Access Compliance Report

Public Rights-of-Way

(Curb Ramps)

Intersection ID: 30329	Main Street: OLD_CONCORD_RD	Cross Street: STOURBRIDGE_LION_DR	Location:	N
ADA ID: 288CECCE0286	Ramp Type: Perp	Initial Pass/Fail: Fail	Overall Compliance: No	Severity Score: 1.25
Codes/Mitigation Info/Possible Solution		Field Measurements/Component Compliance

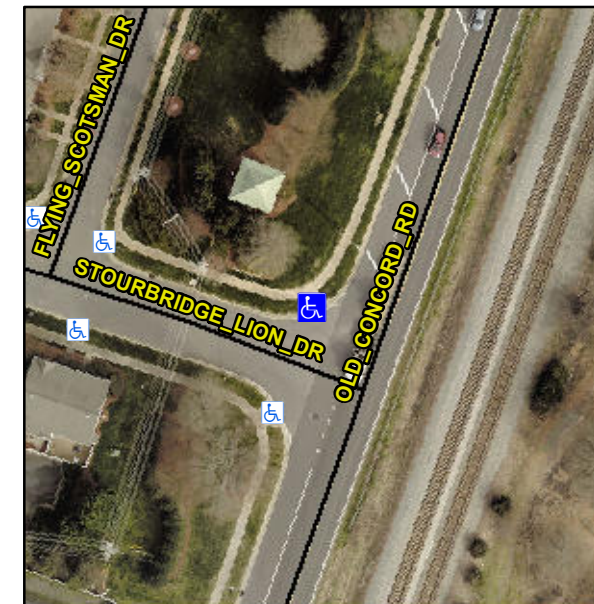
R304.5.3

Compliance	Description	Data	Compliance	Description	Data
N/A	Ramp Length (in)	88.0	Yes	Ramp Slope (%)	7.0
Yes	Ramp Width (in)	50.5	No	Ramp XSlope (%)	3.3
N/A	Flare Type LT	N/A	N/A	Flare Type RT	N/A
N/A	Flare Slope LT (%)	N/A	N/A	Flare Slope RT (%)	N/A
N/A	Flare Traversable LT?	N/A	N/A	Flare Traversable RT?	N/A
N/A	Landing Length (in)	N/A	N/A	DWS Provided?	N/A
N/A	Landing Width (in)	N/A	N/A	DWS Contrast?	N/A
N/A	Landing Slope (%)	N/A	N/A	DWS Length (in)	N/A
N/A	Landing X Slope (%)	N/A	N/A	DWS Full Width?	N/A
N/A	Landing Curb? (Y/N)	N/A	N/A	DWS Offset (in)	N/A
N/A	Shared Landing?	N/A			
N/A	Gutter Ponding?	N/A	N/A	Gutter Slope (%)	N/A
N/A	Gutter Lip Ht (in)	N/A	N/A	Gutter X Slope (%)	N/A
N/A	Painted X Walk1?	No	N/A	Painted X Walk2?	N/A
	X Walk 1 Direction	To SW		X Walk 2 Direction	N/A
N/A	X Walk 1 Width (in)	N/A	N/A	X Walk 2 Width (in)	N/A
	X Walk 1 Slope (%)	0.6		X Walk 2 Slope (%)	N/A
	X Walk 1 X Slope (%)	2.0		X Walk 2 X Slope (%)	N/A

Remove & Replace Entire Ramp.
